VALUE ENGINEERING TEAM STUDY REPORT

Greenup Lock

OHIO RIVER

Sponsored By:
U.S. Army Engineer District, Huntington

600' LOCK EXTENSION
OUTLET WALL DIFFUSER
SCALE: 1"=10'

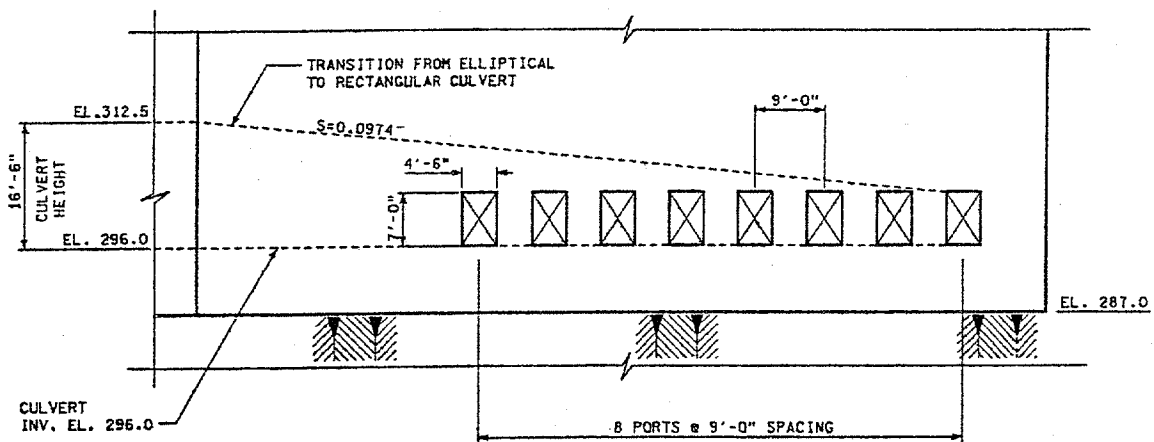
Drawing taken from J.T. Myers and is
shown opposite hand configuration?

PROPOSED DESIGN WITH SLUICE GATE AND CULVERT

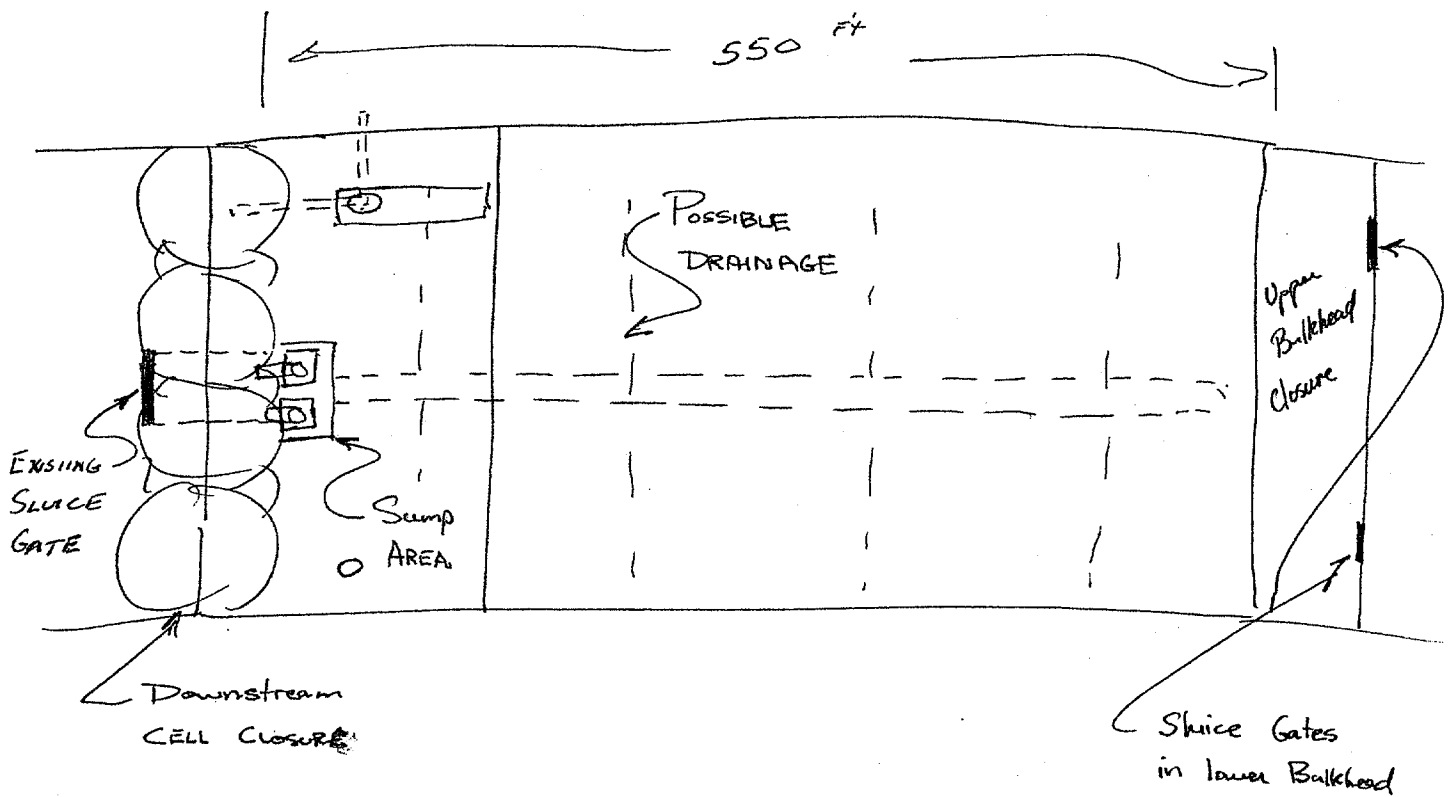
Utilize the existing sluice gate and put a sump directly below. Lower the floor elevation to the bottom of the chamber elevation 495.0 feet. Install 20-inch pumps at the lower end. Build the floor of the dry dock with weep holes. Use heavy aggregate under the concrete for drainage. Eliminate perforated pipe, filter cloth, and dowels. Add sluice gates in the bottom bulkhead for re-watering.

DRAWING NO. 1

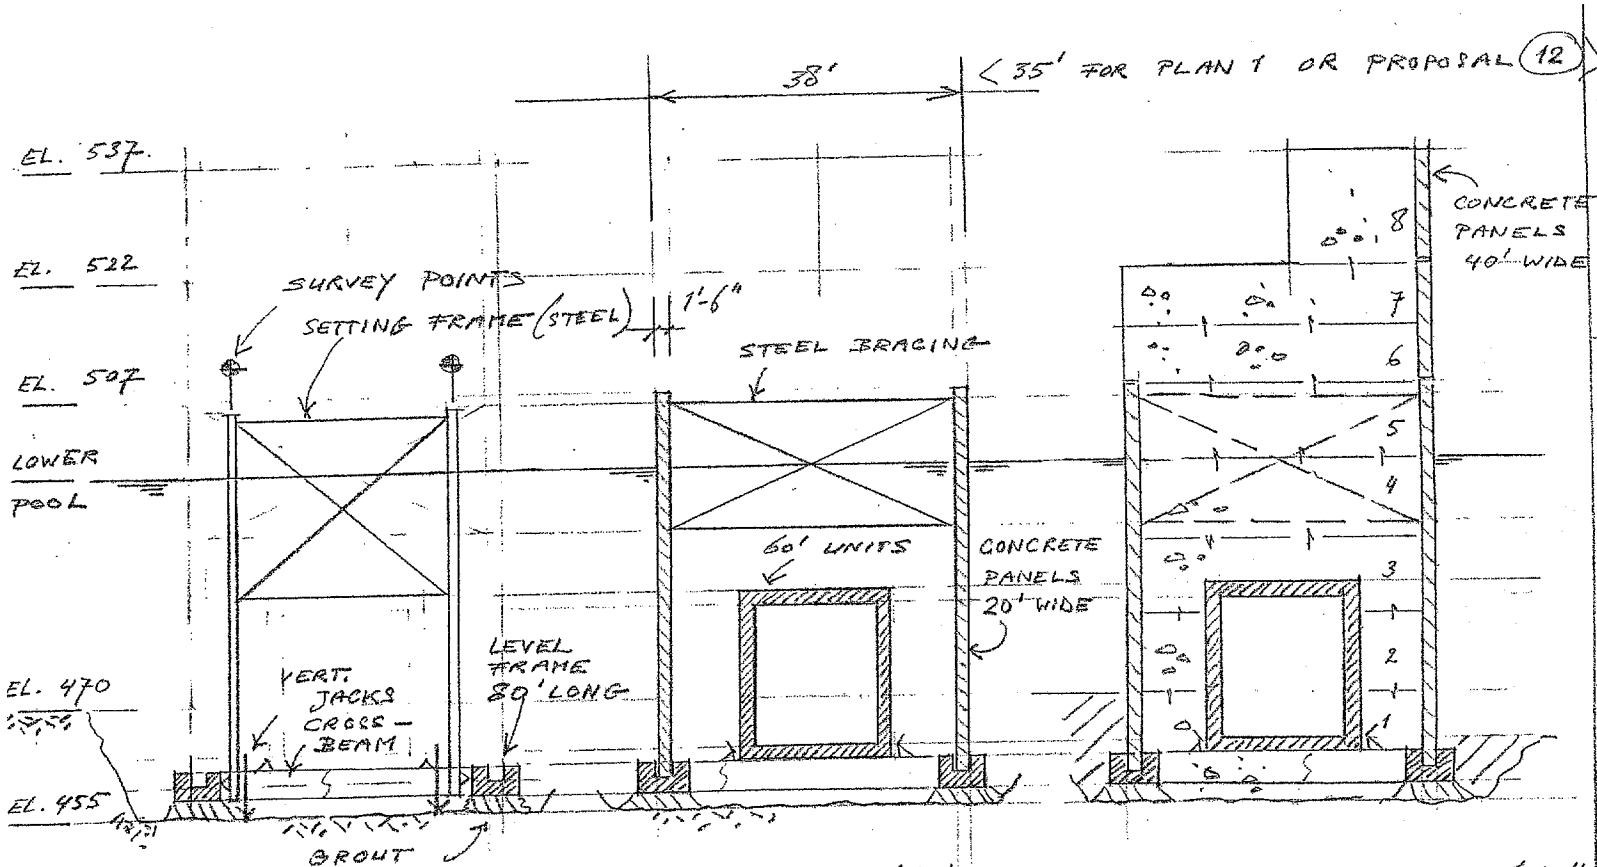
NOTE: Any lift-in system would perform better when the cross over culvert is deleted.

- Refer to Proposal C-12 Drawing No.1.

- Lift-in concrete level frame.
- Grout; remove silting frame.
- Lift-in panels and place bracing.
- De-water between walls.
- Inspect and clean rock surface.
- Build culvert.
- Place CIP concrete pours 7 to 8.

PROPOSED DESIGN WITH FLOAT-IN SECTIONS

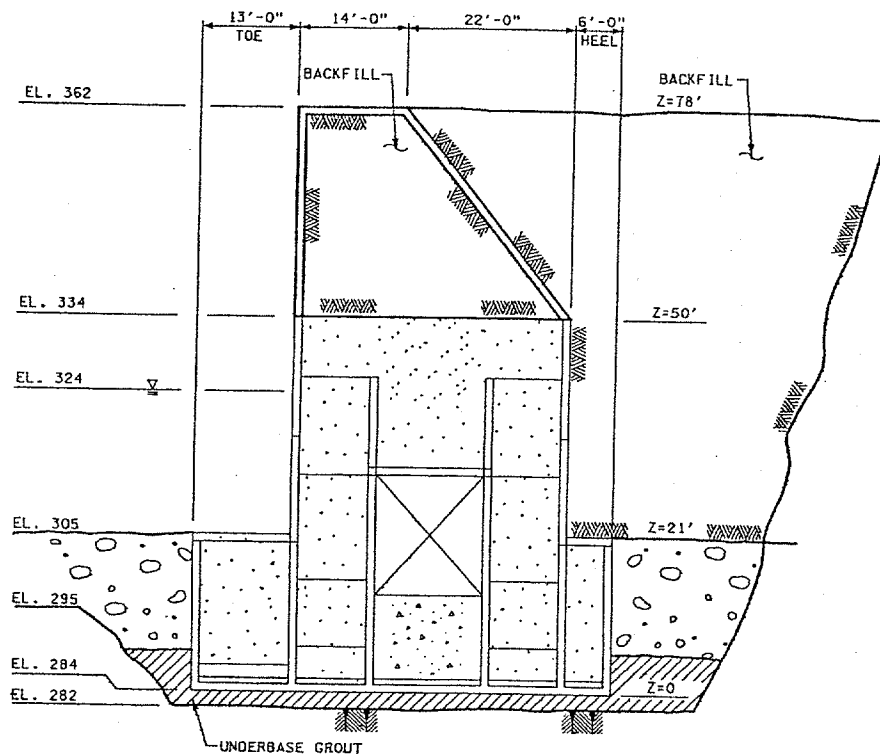
1. CONTINUE SIDEWALL CONSTRUCTION TO 50' ABOVE BOTTOM OF BASE RAFT.
DRAFT = 20'
2. TOW TO FINAL LOCATION.
3. TIE ADDITIONAL 12" THICKNESS STRUCTURAL CONCRETE SLAB TO KEEL SLAB.
4. BALLAST BENEATH CULVERT, HEEL AND TOE COMPARTMENTS TO LOWER WALL STRUCTURE TO EL. 284.

PROPOSED DESIGN WITH FLOAT-IN MITER GATE BAY

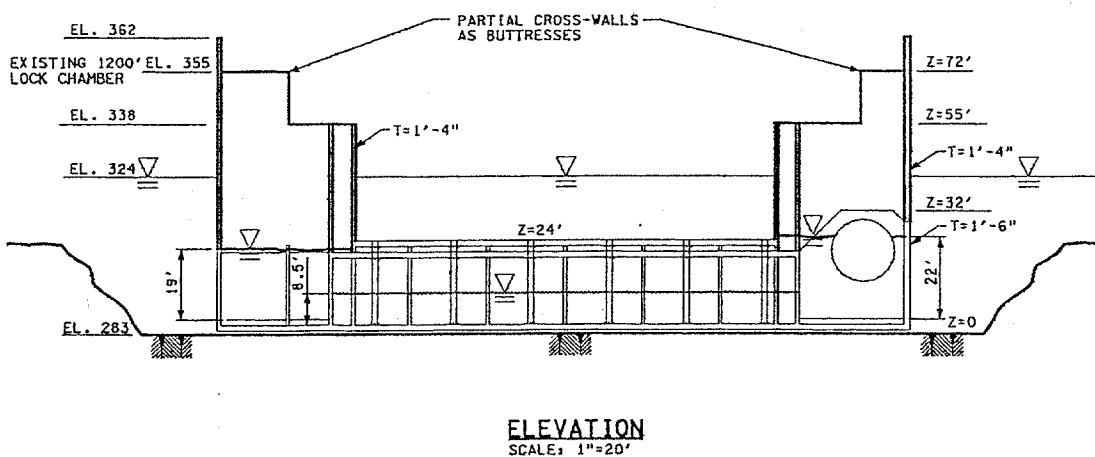
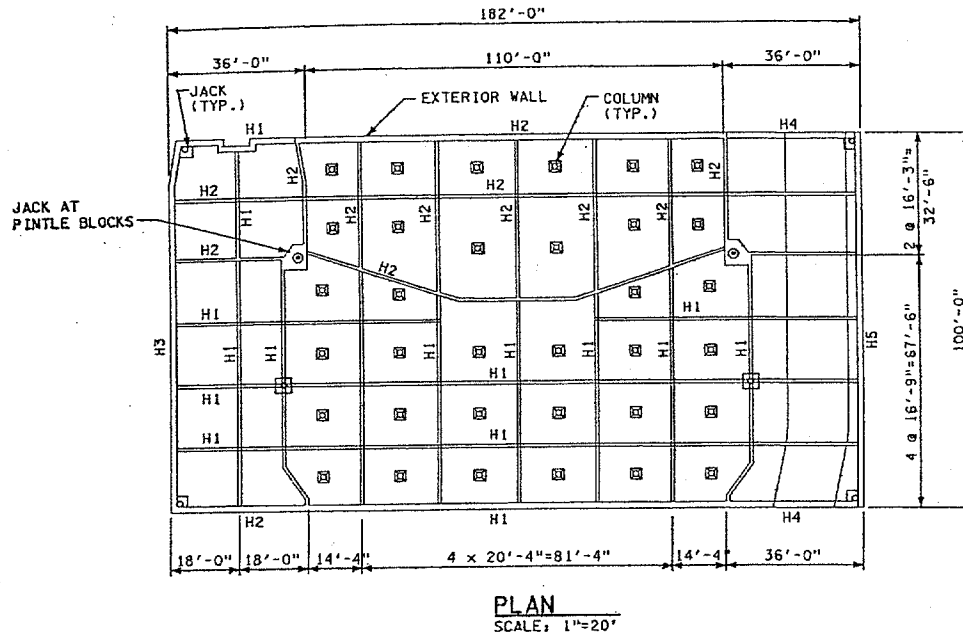
1. CONSTRUCT EXTERIOR SIDE WALLS TO EL. 362 AND INSIDE SIDE WALLS TO EL. 338. USE WATER BALLAST FOR TRIM.
2. TOW FROM OUTFITTING PIER (CONSTRUCTION MOORAGE AREA) TO SET-DOWN LOCATION. DRAFT APPROX. 21.1'.
3. ADD WATER BALLAST IN ACCORDANCE WITH ENGINEERED AND APPROVED BALLAST PLAN TO SET-DOWN STRUCTURE ON EITHER JACKING LEGS OR CONCRETE PEDESTALS WITH FLAT JACKS.

PROPOSED DESIGN RELOCATING FILL VALVE

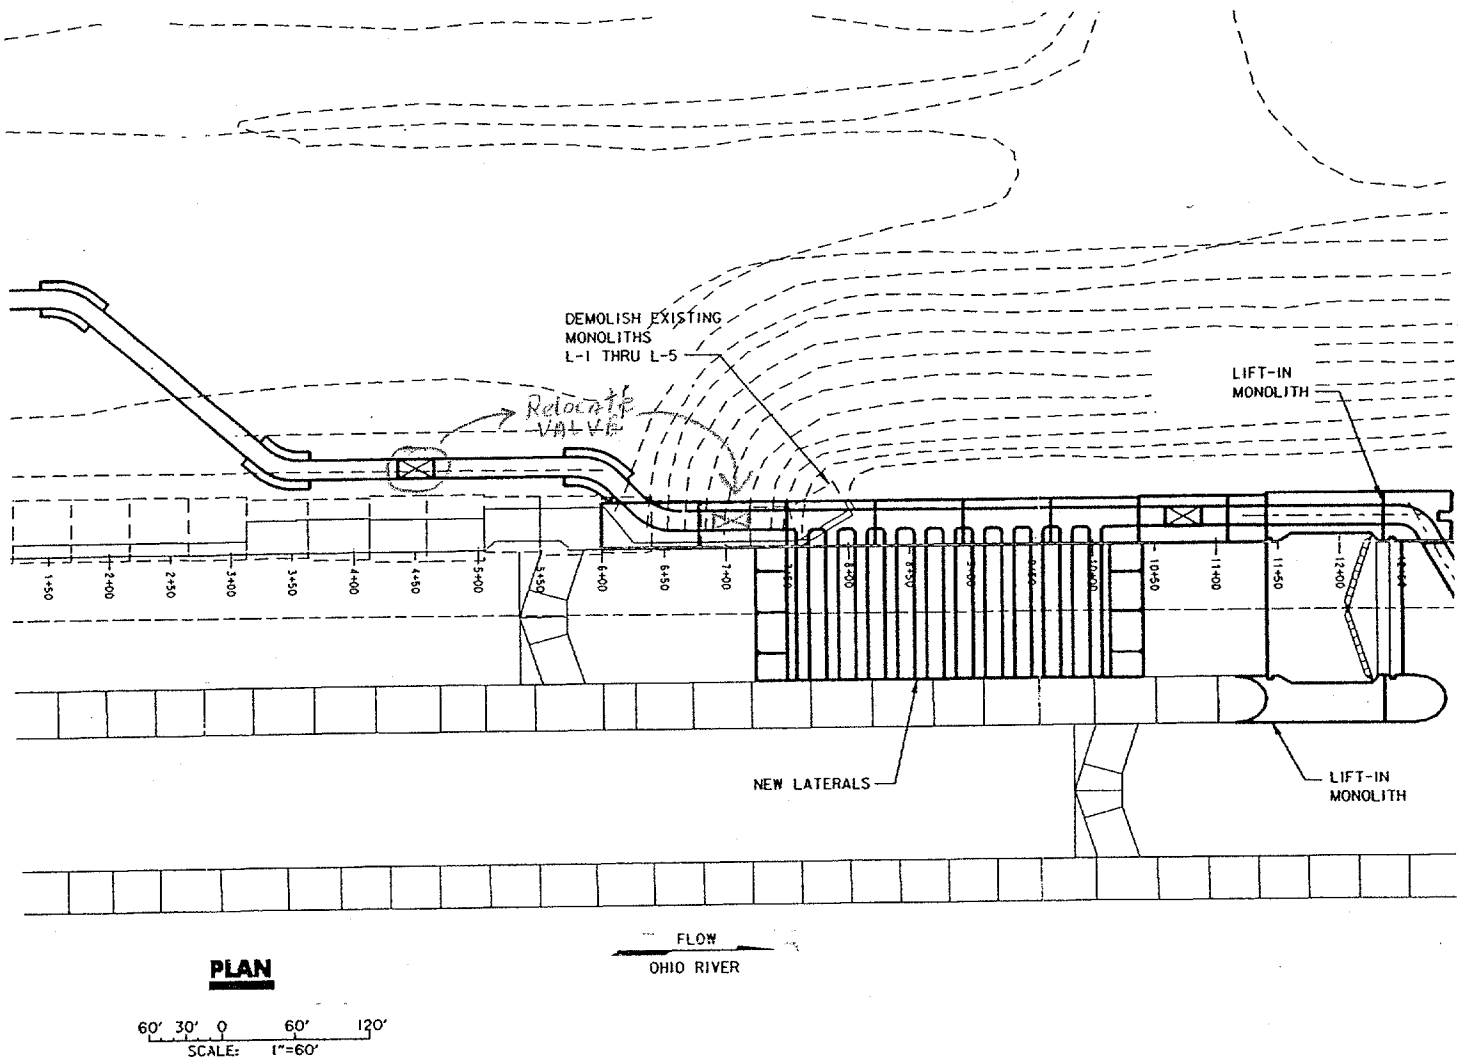
Relocate the filling valve from esplanade (Station 4+50) to within the lockwall at Station 7+00. (See Drawing No 2).

PROPOSED DESIGN WITH ENTRY POINT DOWNSTREAM

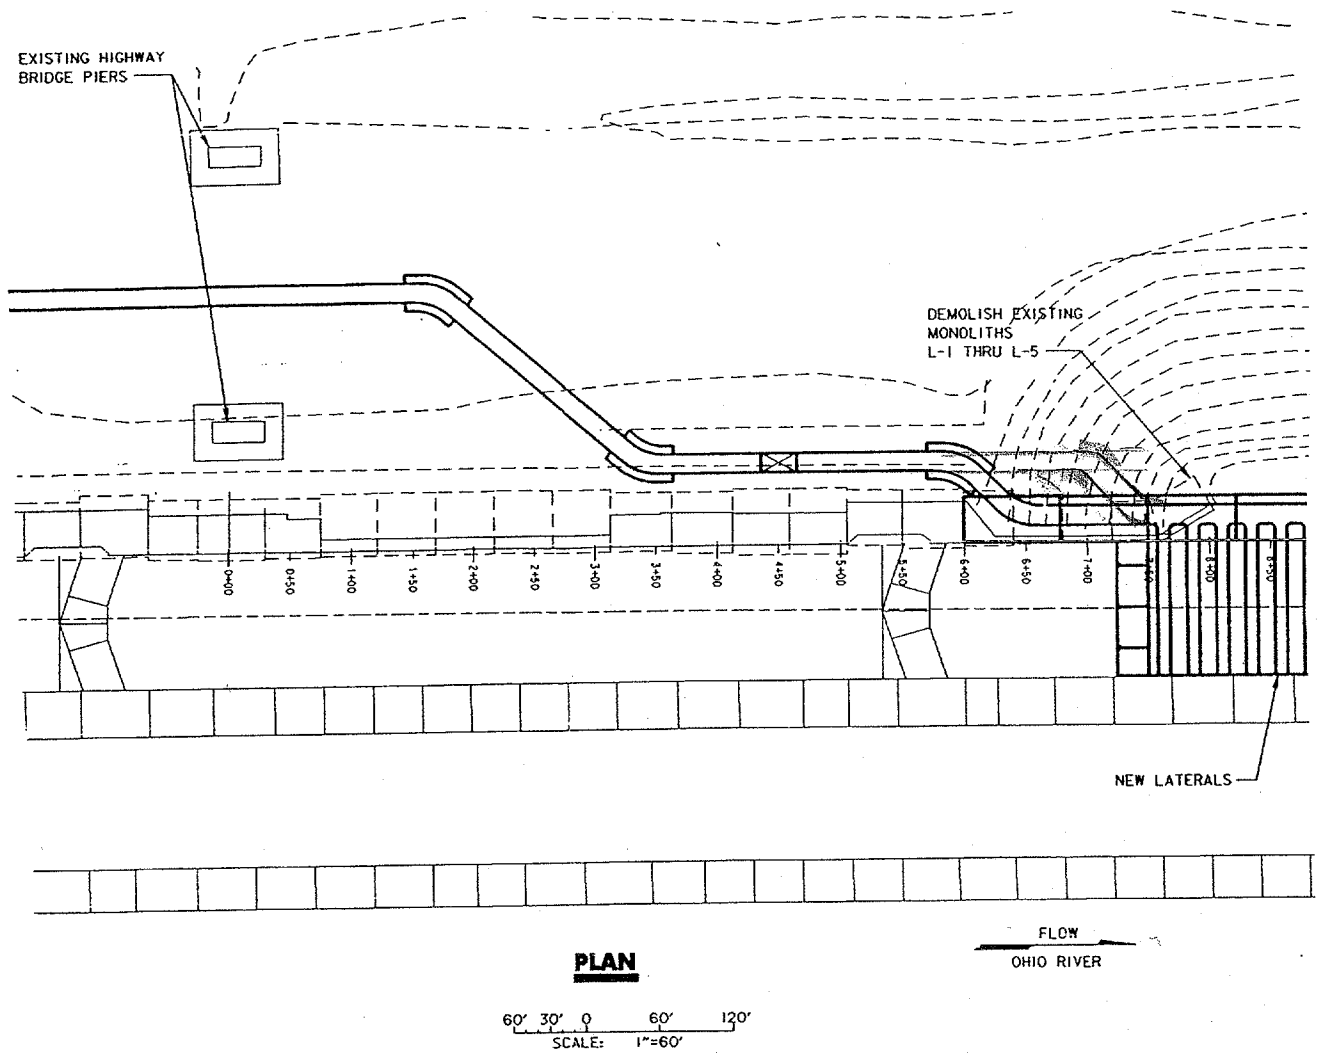
Change the point from where the culvert enters the landwall at station 6+25 to station 7+25. (See Drawing No 2).

PARTIAL PLAN OF PUMPING STATION FILLING SYSTEM

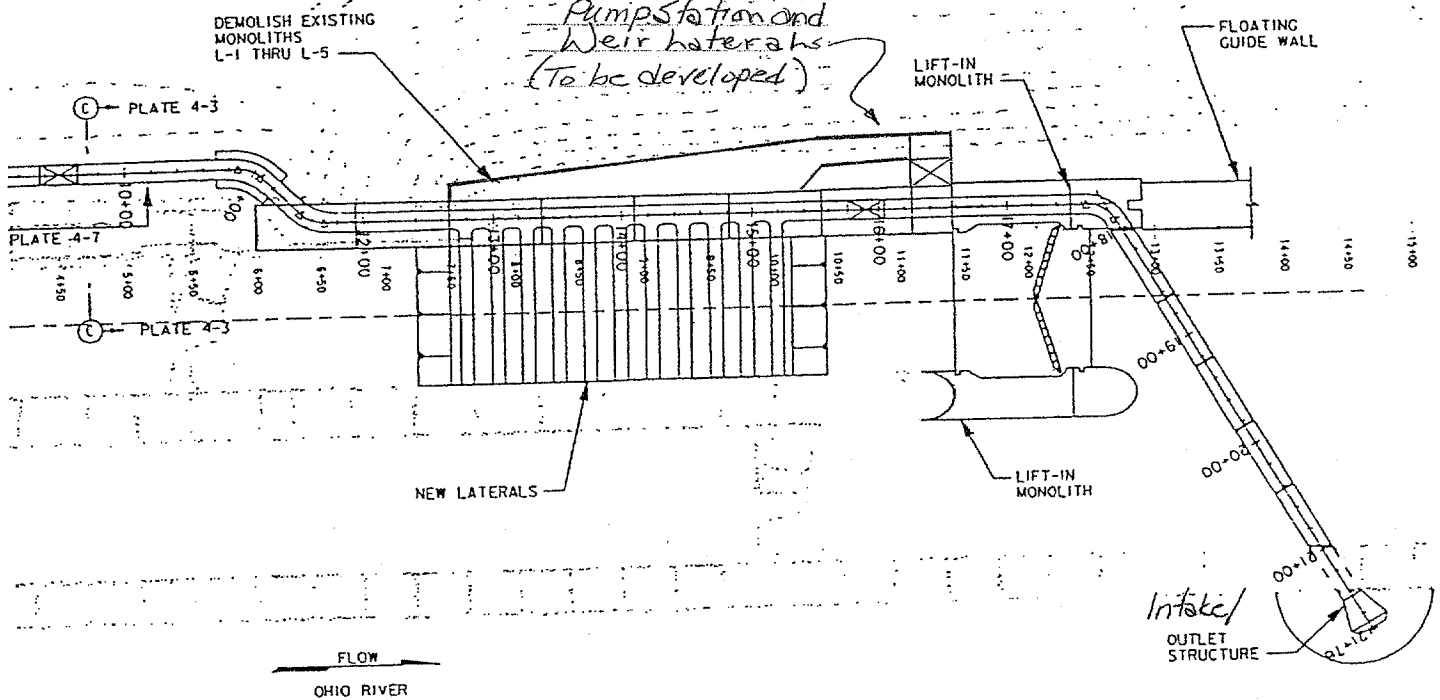
It is recommended that the new filling system incorporate a 1,600 CFS pump station to pump lower pool water to fill the lock. A filling weir feeding system will pass fill water to the new laterals. The existing culvert and laterals remain in service. The existing and new emptying system remains unchanged, however the new emptying culvert may be developed as the filling culvert to the new pump station. (See Drawing No. 2).

PROPOSED DESIGN

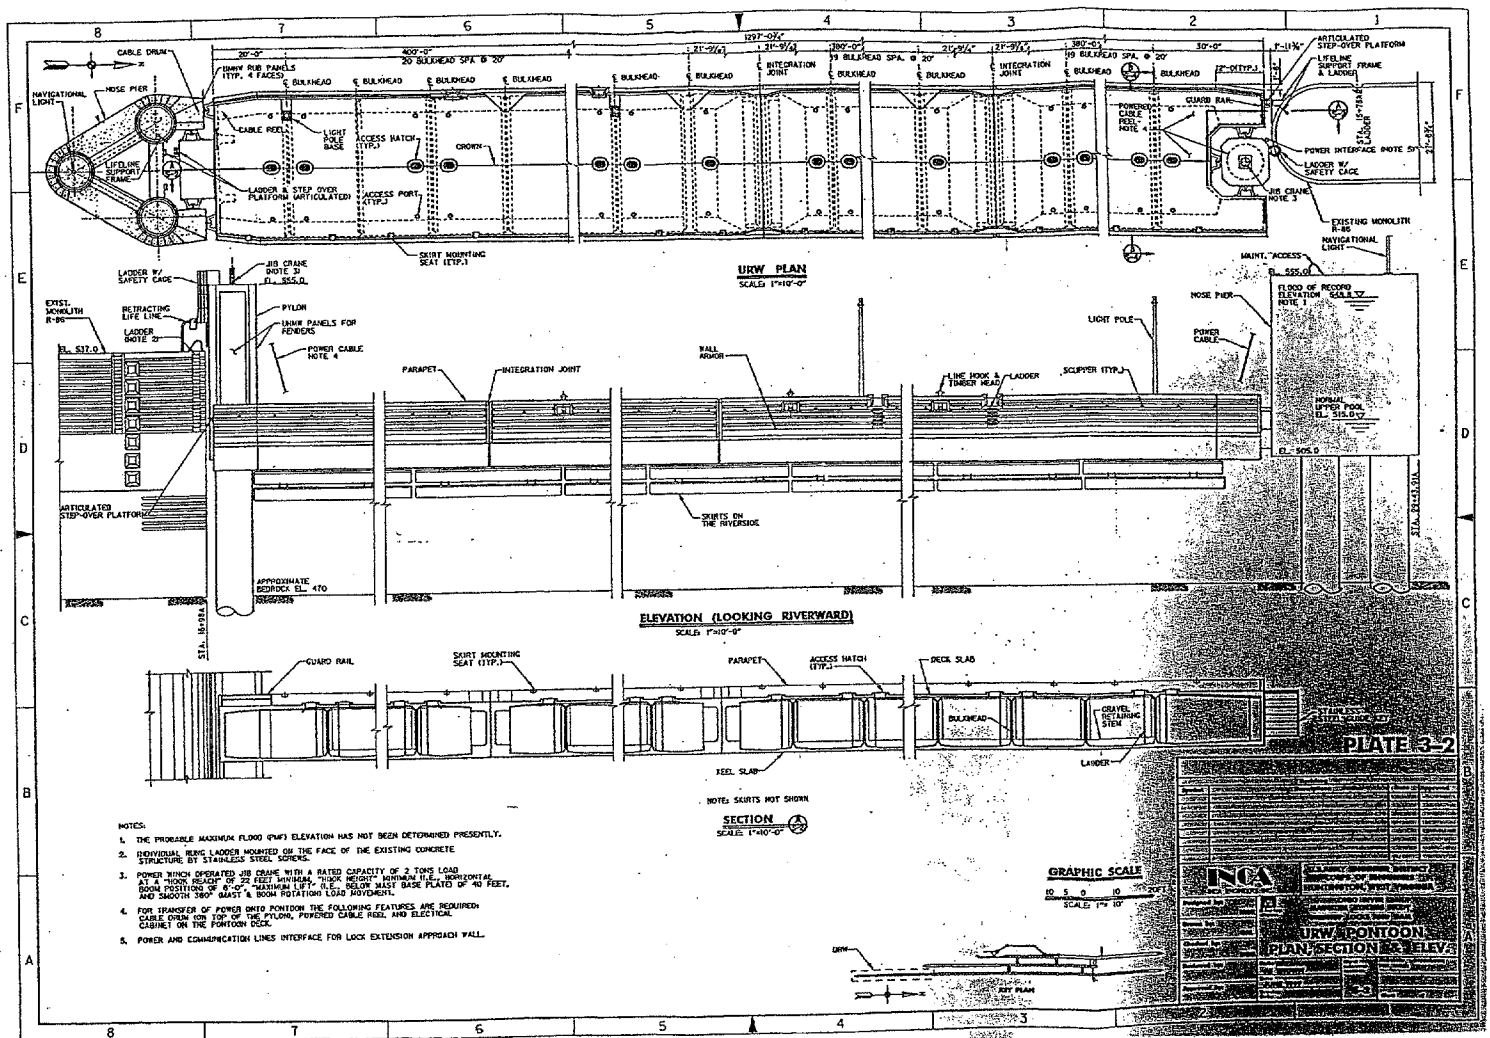
High-mast compliments the existing lighting system. There would be no inventory increases due to incompatibility of parts. It would provide the same level of lighting safety.
